April 7, 1975

**SUBJECT: REVISION TO ABNORMAL OCCURRENCE REPORT ON DRESDEN UNIT 2 CORE SPRAY INJECTION LINE THROUGH-WALL CRACKS**

Reference: 1) Letter #78-75 from B. B. Stephenson to J. G. Keppler dated February 6, 1975

"A" LOOP

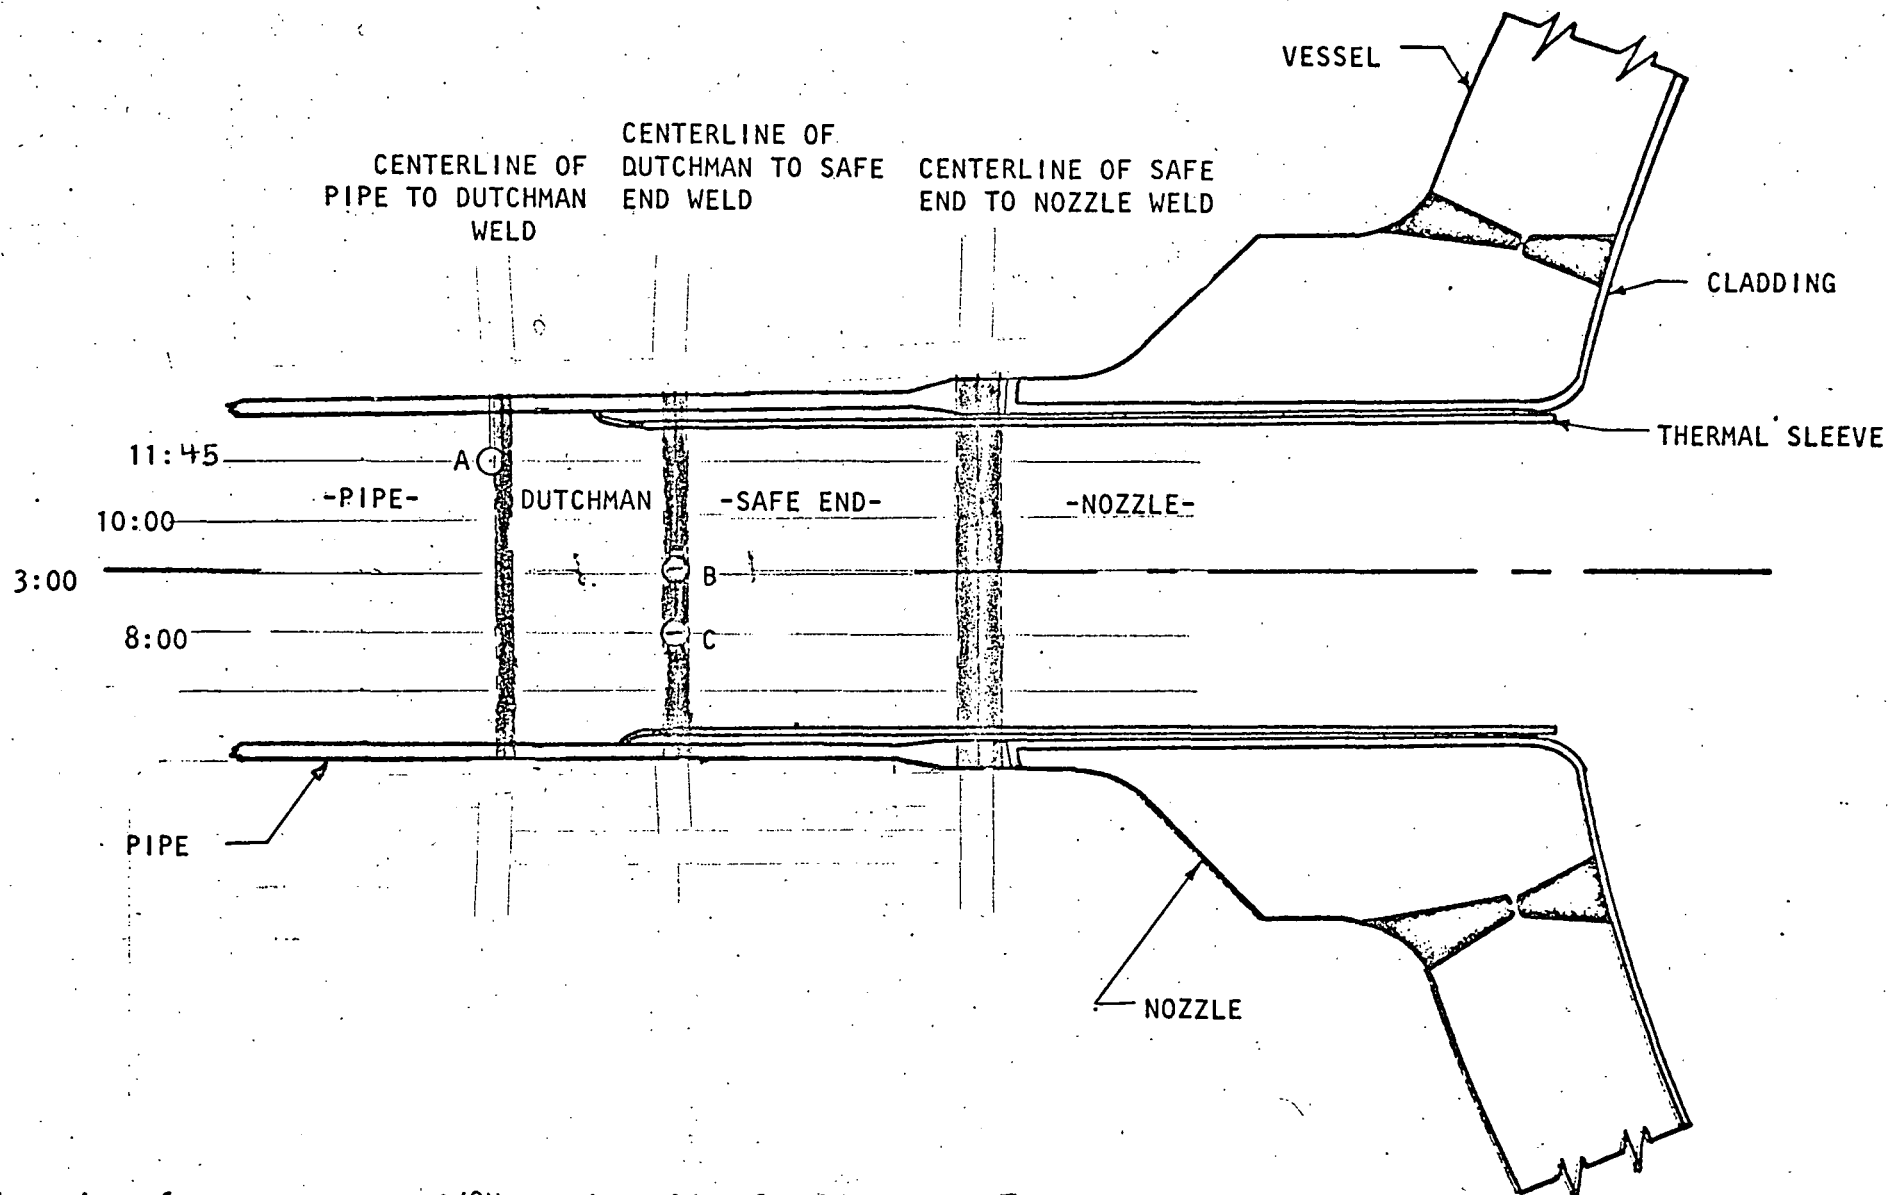
As a result of an inquiry into the actual location of the dye penetrant indications versus the weeper on Core Spray nozzle "B", the drawings were reviewed for their accuracy. It appears that the proper location of the indications are in error. In addition, on "A" Core Spray Nozzle drawing, the clockwise location of the visible weeper was also revised to reflect previously reported information. Attached are drawings of "A" & "B" 10 inch Core Spray nozzles with appropriate changes made.

A⊕ - Location of weeper approx. 1/8" on pipe side of weld at 11:45

B⊖ - Location of crack approx. in centerline of Dutchman to Safe End weld at 3:00-9/16" in Length.

C⊖ - Location of crack approx. in centerline of Dutchman to Safe End weld at 8:00-5/8" in Length.

"B" LOOP

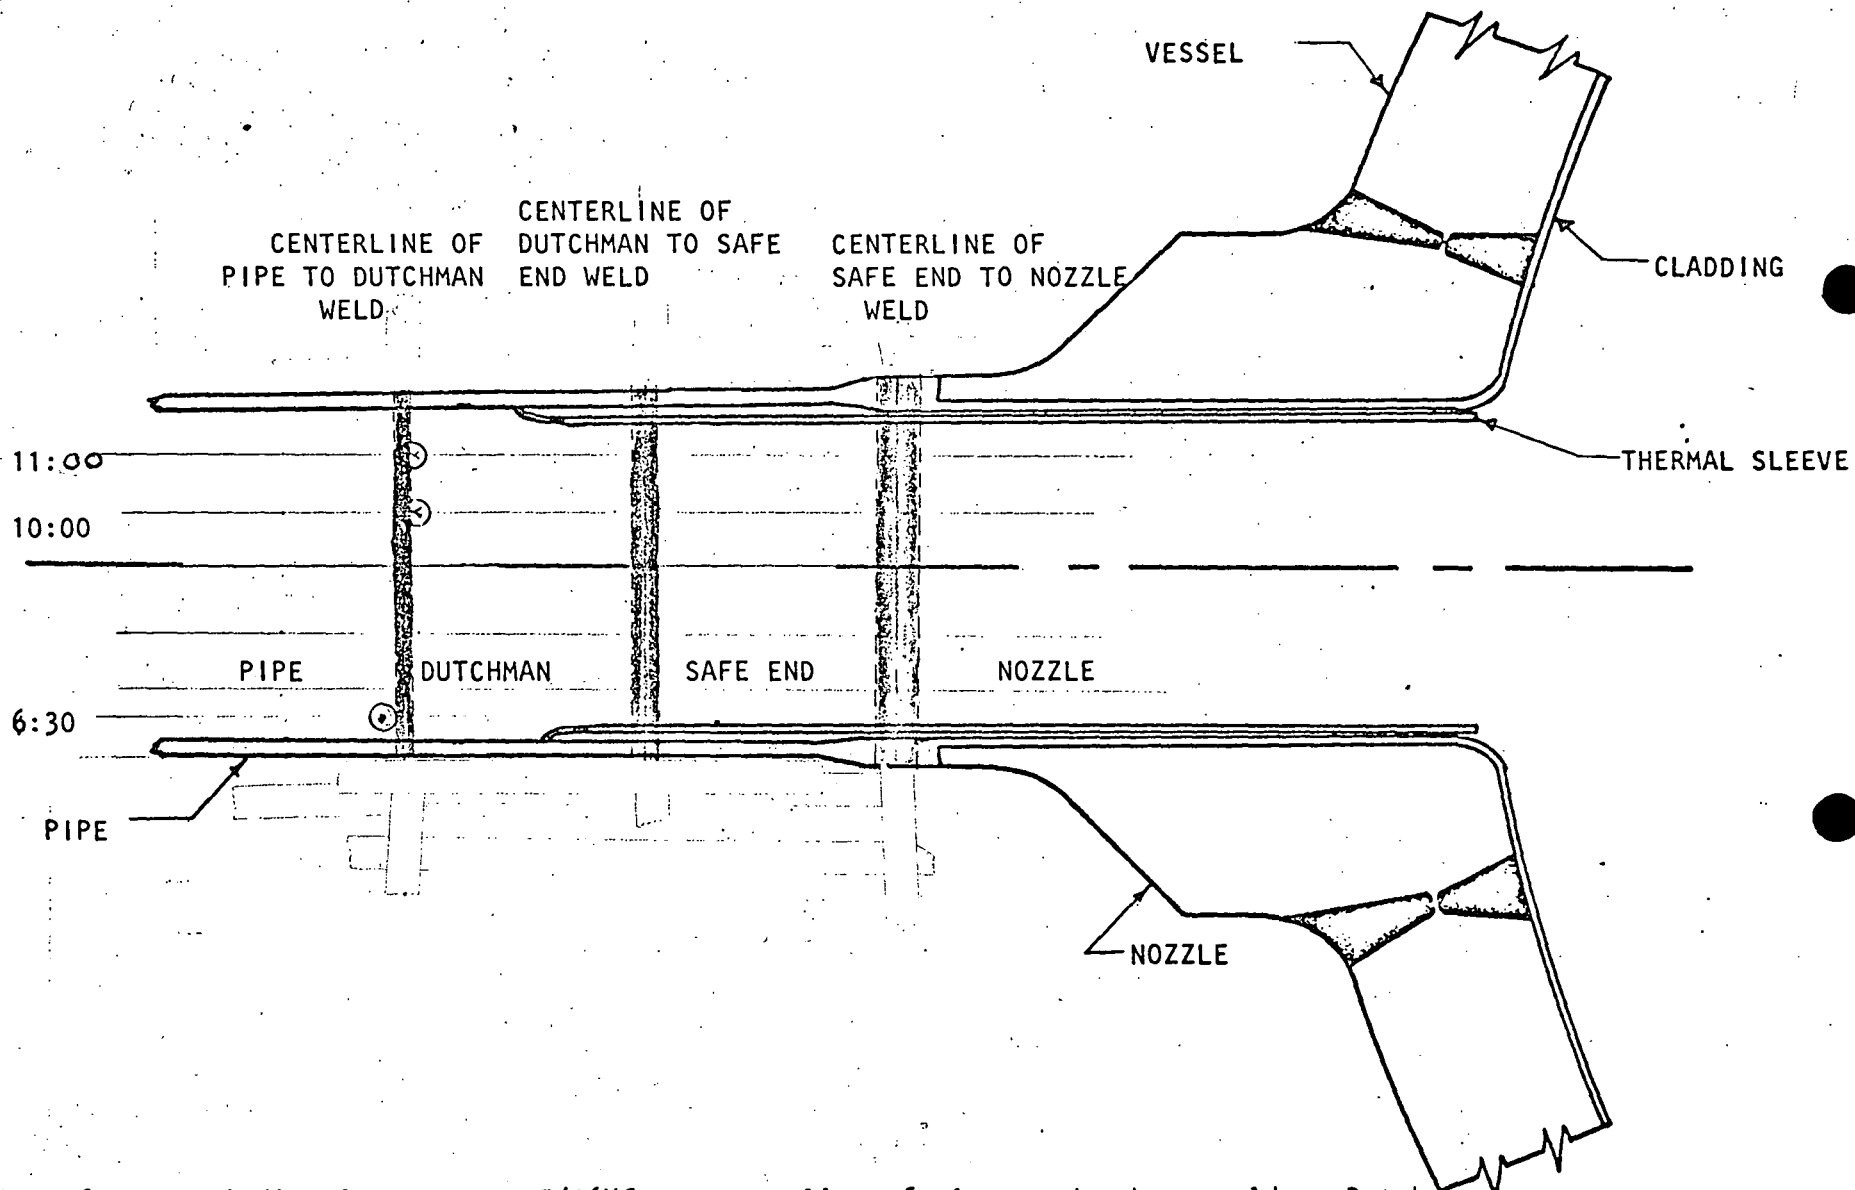
① - Location of weeper indication approx.  $5/16$ " from centerline of pipe to dutchman weld on Dutchman.

② - Location of PT indication, approx.  $5/8$ " from centerline of weld on pipe side.
